Rezoning Transportation Analysis

Petition Number: 2026-037

Date	Description
6-25-26	First Review (IW)

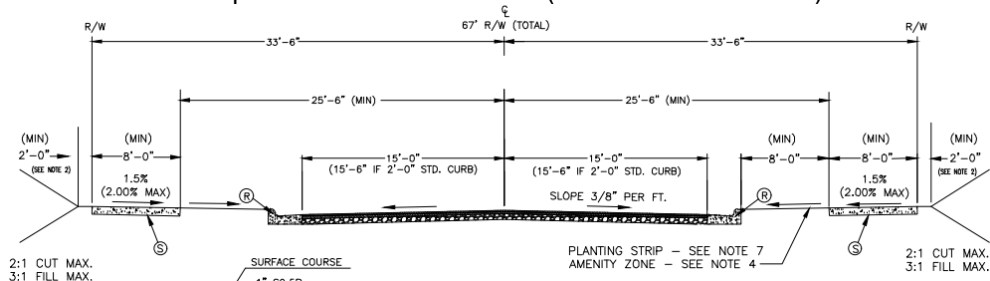
- b. ~~Sanders Avenue: Location of future back of curb and gutter needs is 17.5' from centerline and the future location of curb and gutter is in its existing location.~~

~~CLDSM standard per Table 33-2 in article 33 (and meets condition 3): Residential Wide U-04A.~~

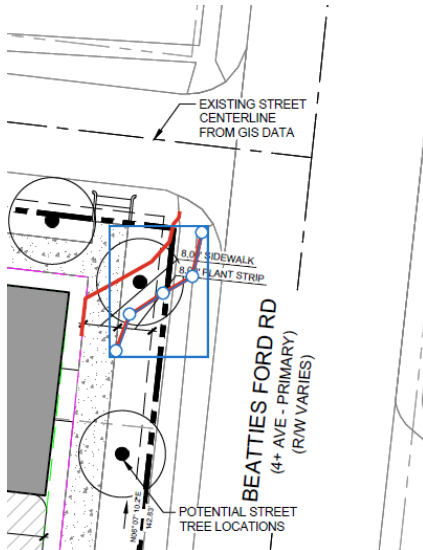
~~Label and dimension the curb and gutter from the centerline for each road on the site plan.~~

3. Revise site plan and conditional note(s) to commit to dedicate 48.5 feet of right-of-way from the road centerline. The site plan shall label **and dimension** the right-of-way from the Beatties Ford Road road centerline.

4. Revise site plan and conditional note(s) to commit to dedicate 25.5 feet of right-of-way from the road centerline. The site plan shall label **and dimension** the right-of-way from the Sanders Ave road centerline.

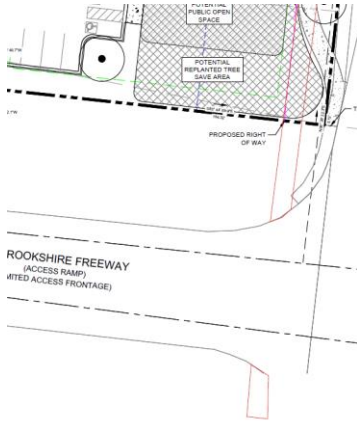
9. **CDOT REQUEST:** Revise site plan and conditional note(s) to commit to extending the sidewalk to the W. Brookshire Freeway and reconstructing ramps on both sides. This will assist in better and safer pedestrian facilities and assist in the city's Vision Zero efforts. NCDOT maintains W. Brookshire Freeway and have stated they would not have an issue with this adjustment.
